**JULY 16, 2013 ZONING HEARING
"OTHER BUSINESS"
COMMISSION DISTRICT 1**

To consider approval of an R-20 Open Space Community Overlay application for The Pacific Group, Inc. regarding Application OSC 13-02 filed May 6, 2013, for property located southwesterly side of Stilesboro Road; west of New Salem Road; east of Kennesaw Due West Road in LL's 241 of the 20th District, Cobb County, Georgia.

PETITION NO: OSC 13-02

PLANNING DIVISION COMMENTS

OSC 13-02 REVISED PLAN 06-21-13

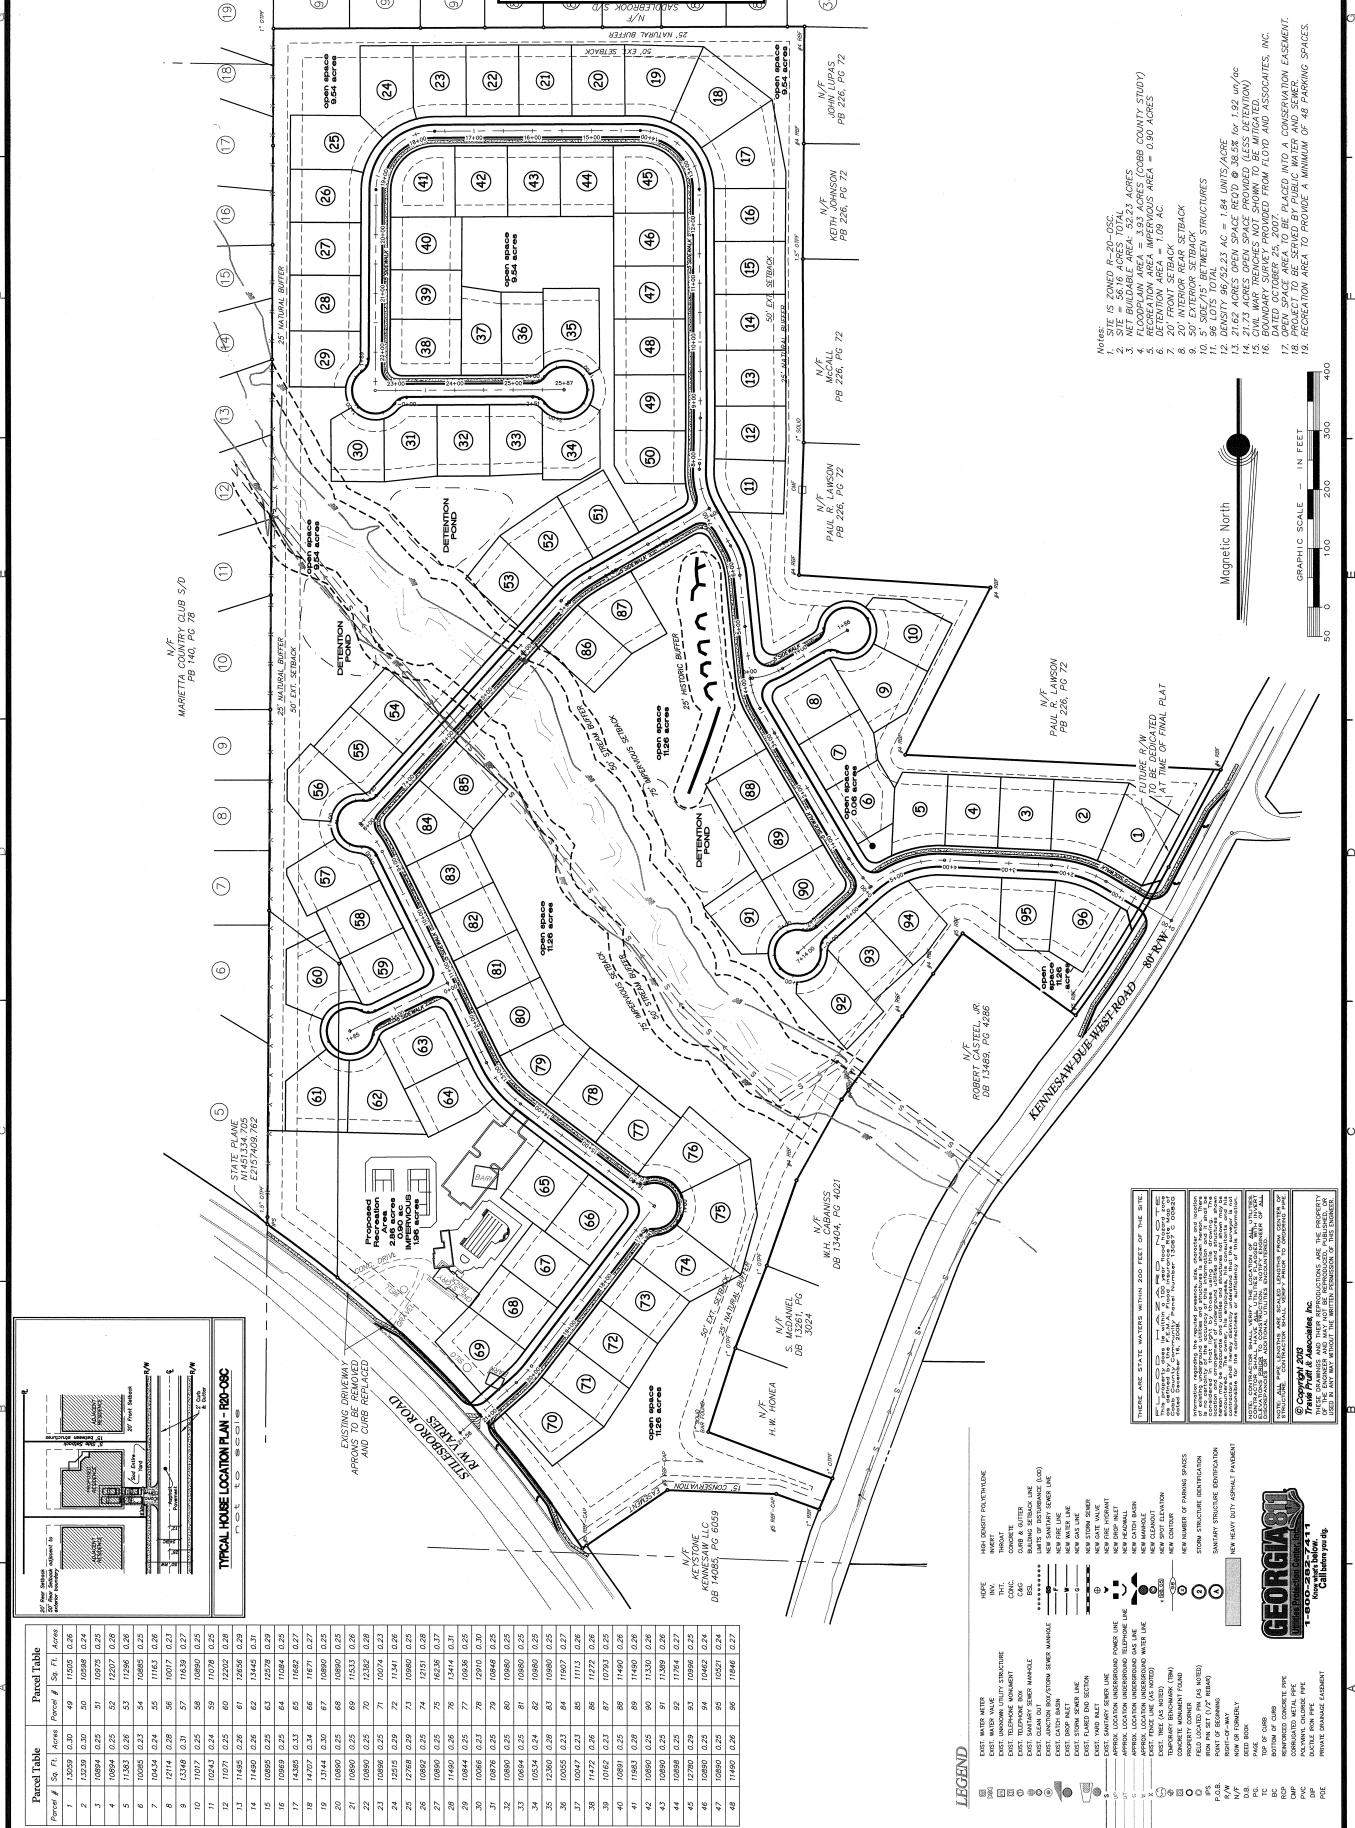
1. Lots 82 and 92 should be completely above Floodplain
2. Civil War earthworks have been observed on site. Please provide a plan that depicts location, orientation and type of earthworks that exist on property and include the historic area to be protected within the required Open Space unless other measures have been agreed upon.

5. Staff recommends maintaining the 25' natural buffer for lots 10 through 29 until Certificate of Occupancy has been issued for each of the lots.
6. Note on site plan that Detention Pond areas are subtracted out of the required open space.

The plan appears to properly account for the 100-year floodplain and stream buffers on the site. However, I do not think that the straight R-20 plan is a valid one, since it does not account for area needed for detention. If you overlay the detention ponds shown on the OSC layout you would have to eliminate lots 77, 78, 89 & 90 and parts of lots 44, 45, 46 & 47. Also, several lots do not have the necessary 12,500 sf minimum area above the floodplain to be buildable. These include lots 75, 76, 77, 80, 81, 82 & 83.
